Report Title **Investigations for the Upgrading of Lucy’s Mill Footbridge, Stratford-upon-Avon**

**Investigations for the Upgrading of Lucy's Mill Footbridge,
Stratford-upon-Avon**

Refurbishment of Lucy's Mill Footbridge, Feasibility Report
(November 2006)

Proposed New Footbridge By Stratford Voice, Feasibility Report
(March 2008)

TITLE
LUCY'S MILL FOOTBRIDGE
STRATFORD UPON AVON
OPTION A

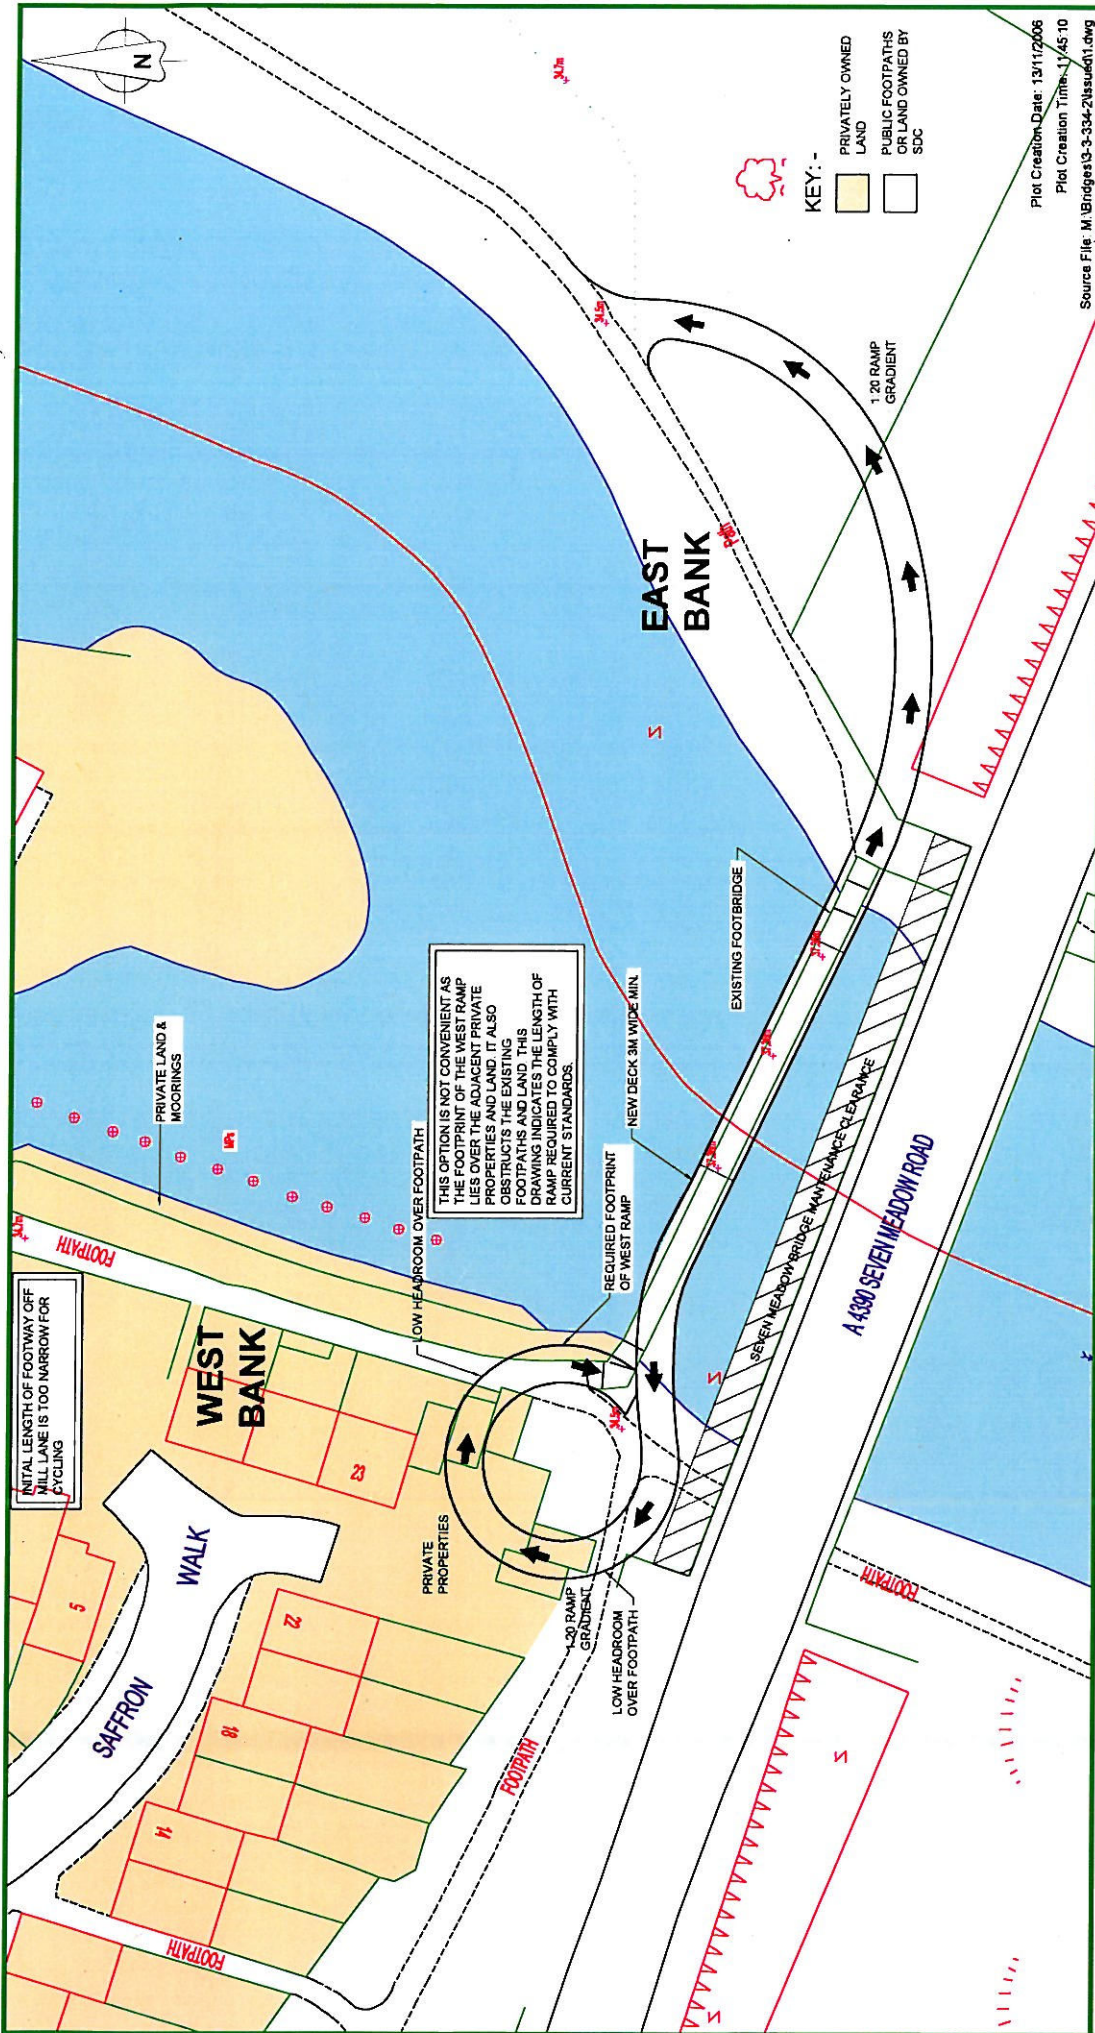
Option A is not feasible even if private land was available since the circular ramp will obstruct two existing footpaths.

INITIAL LENGTH OF FOOTWAY OFF MILL LANE IS TOO NARROW FOR CYCLING

THIS OPTION IS NOT CONVENIENT AS THE FOOTPRINT OF THE WEST RAMP LIES OVER THE ADJACENT PRIVATE PROPERTIES AND LAND. IT ALSO OBSTRUCTS THE EXISTING FOOTPATHS AND LAND. THIS DRAWING INDICATES THE LENGTH OF RAMP REQUIRED TO COMPLY WITH CURRENT STANDARDS.

OPTION B

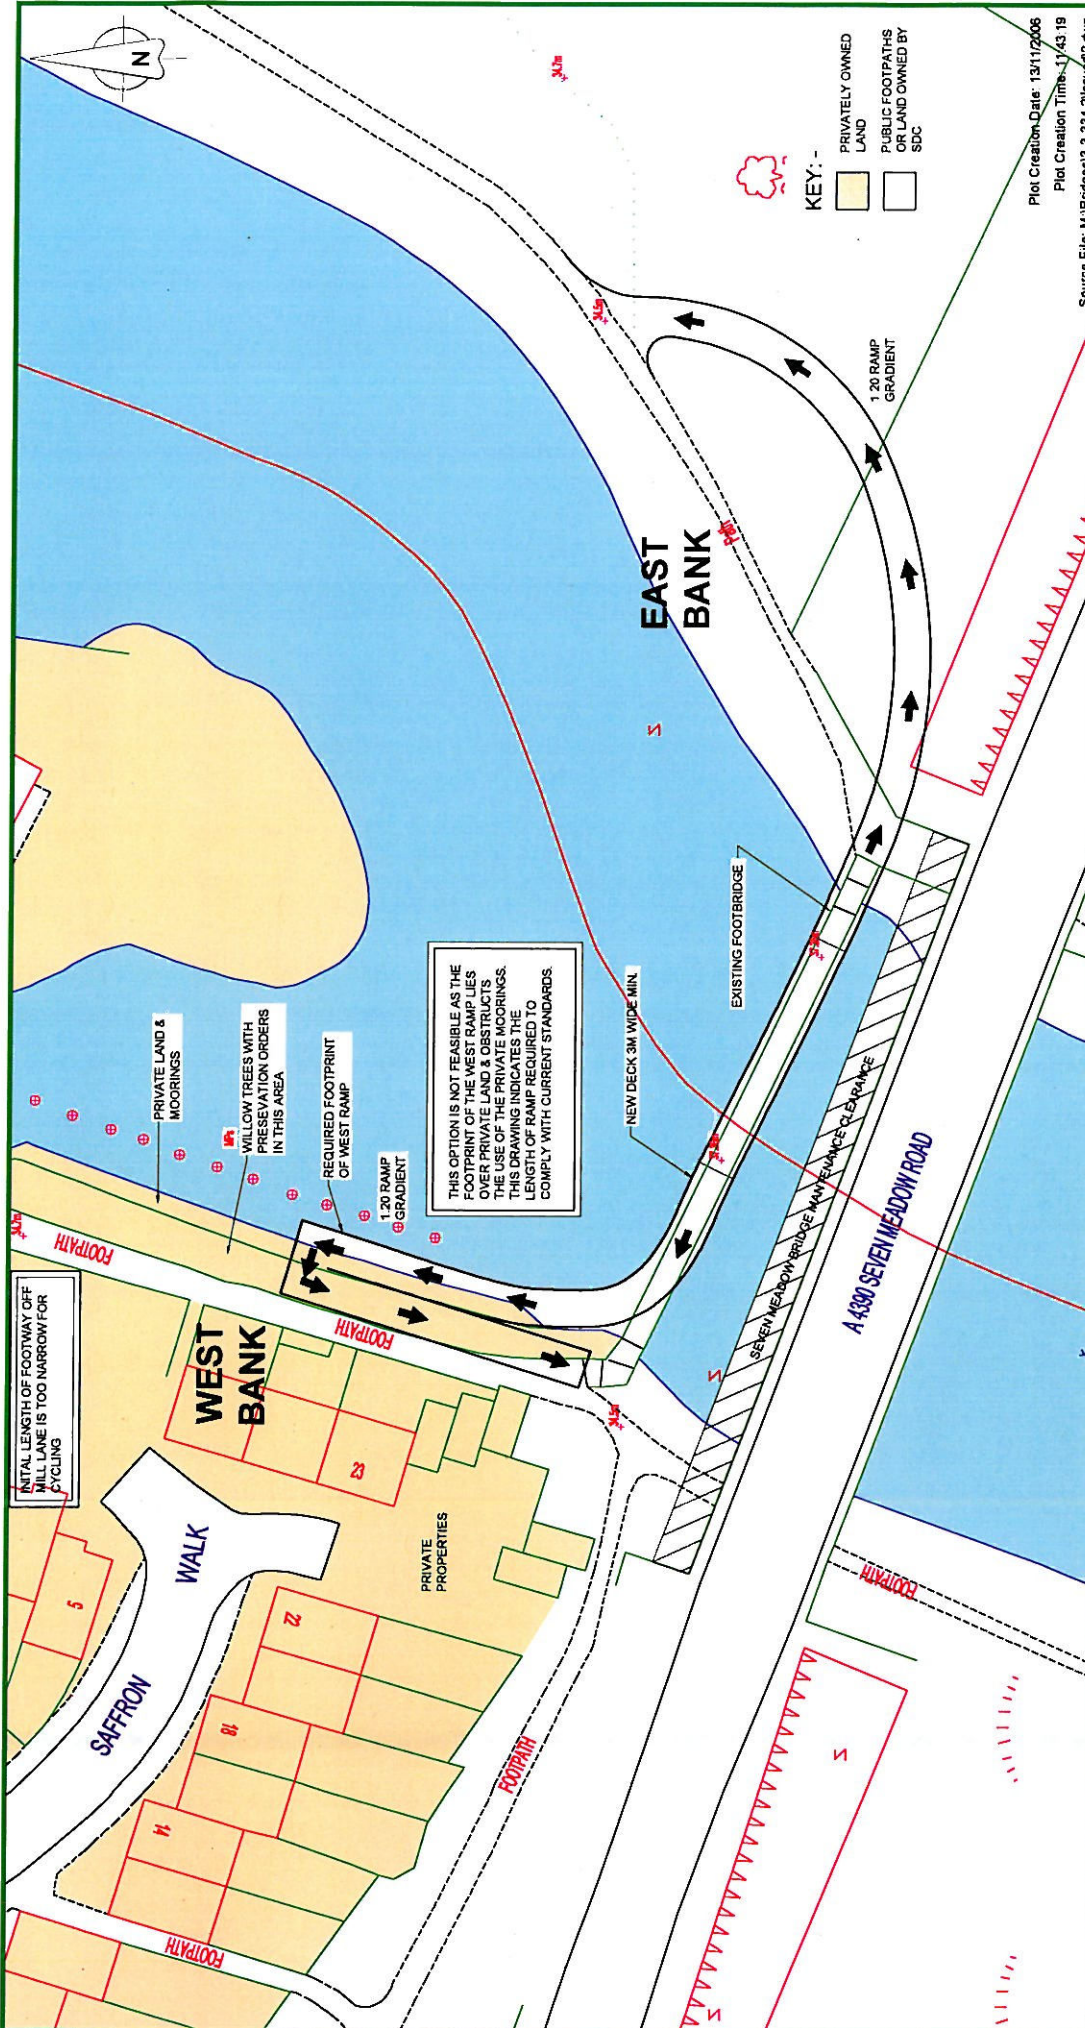
Option B is possible subject to acquisition of private owned moorings and approval by the Environment Agency. However, discussions with a representative of the 20 shared owners of the moorings indicate that they are not prepared to sell the land and thus compulsory purchase order (CPO) is the only available course of action to acquire this land. However, it is considered that a CPO may not be granted for this land. Furthermore, any part of the ramp being suspended over the river and encroaching into the flood level envelope will obstruct river flows in a flood event and hence EA will not endorse such proposals, particularly at this point since this is a "bottleneck" for the river. In addition, the row of willow trees which are subject to a TPO will need to be cut. Therefore, Option B is also not feasible.

TITLE
 LUCY'S MILL FOOTBRIDGE
 BRIDGE FOOTPRINT FOR PROPOSAL MADE
 BY STRATFORD VOICE IN FEB / MARCH 2008

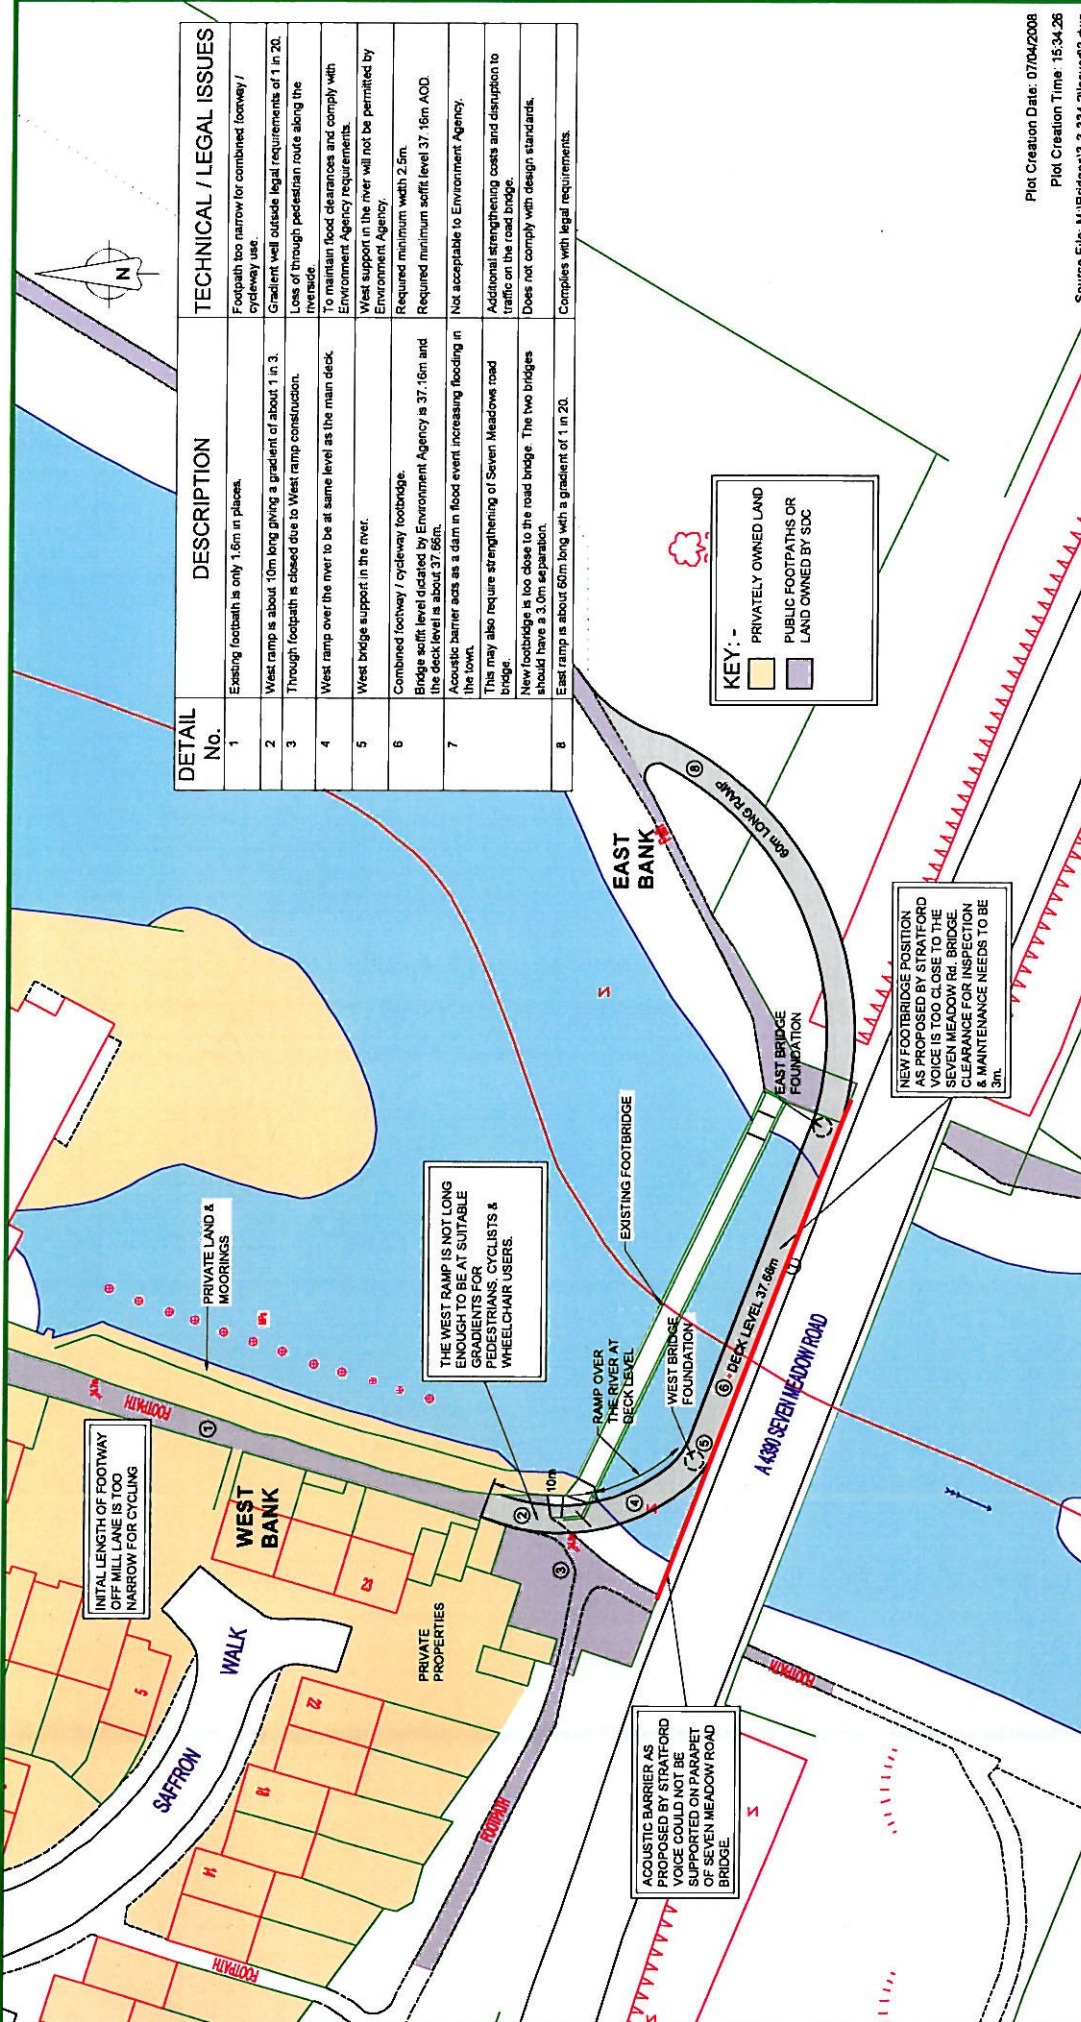
The footpath approaching the bridge on the west bank is narrow for combined footway and cycleway use. In places this is as narrow as 1.6m. The minimum width required for combined use is 2.5m. See the attached drawing number 3.3/334/2/3

The proposal appears to show that the location of the west bridge support is in the river (see attached drawing). Discussions with Environment Agency have shown that a bridge support in the river would not be acceptable since it is likely to act as an obstruction to river flow.

DETAIL No.	DESCRIPTION	TECHNICAL / LEGAL ISSUES
1	Existing footpath is only 1.6m in places.	Footpath too narrow for combined footway / cycleway use.
2	West ramp is about 10m long giving a gradient of about 1 in 3.	Gradient well outside legal requirements of 1 in 20.
3	Through footpath is closed due to West ramp construction.	Loss of through pedestrian route along the meadows.
4	West ramp over the river to be at same level as the main deck.	To maintain flood clearances and comply with Environment Agency requirements.
5	West bridge support in the river.	West support in the river will not be permitted by Environment Agency.
6	Combined footway / cycleway footbridge.	Required minimum width 2.5m.
7	Bridge sciff level dictated by Environment Agency is 37.16m and the deck level is about 37.66m.	Required minimum sciff level 37.16m AOD.
8	Acoustic barrier acts as a dam in flood event increasing flooding in the town.	Not acceptable to Environment Agency.

This may also require strengthening of Seven Meadows road bridge.	Additional strengthening costs and disruption to traffic on the road bridge.
	New footbridge is too close to the road bridge. The two bridges should have a 3.0m separation.	Does not comply with design standards.
	East ramp is about 60m long with a gradient of 1 in 20.	Complies with legal requirements.

NEW FOOTBRIDGE POSITION AS PROPOSED BY STRATFORD VOICE IS TOO CLOSE TO THE SEVEN MEADOW RD. BRIDGE CLEARANCE FOR INSPECTION & MAINTENANCE NEEDS TO BE 3m.

THE WEST RAMP IS NOT LONG ENOUGH TO BE AT SUITABLE GRADIENTS FOR PEDESTRIANS, CYCLISTS & WHEELCHAIR USERS.

ACOUSTIC BARRIER AS PROPOSED BY STRATFORD VOICE COULD NOT BE SUPPORTED ON PARAPET OF SEVEN MEADOW ROAD BRIDGE.
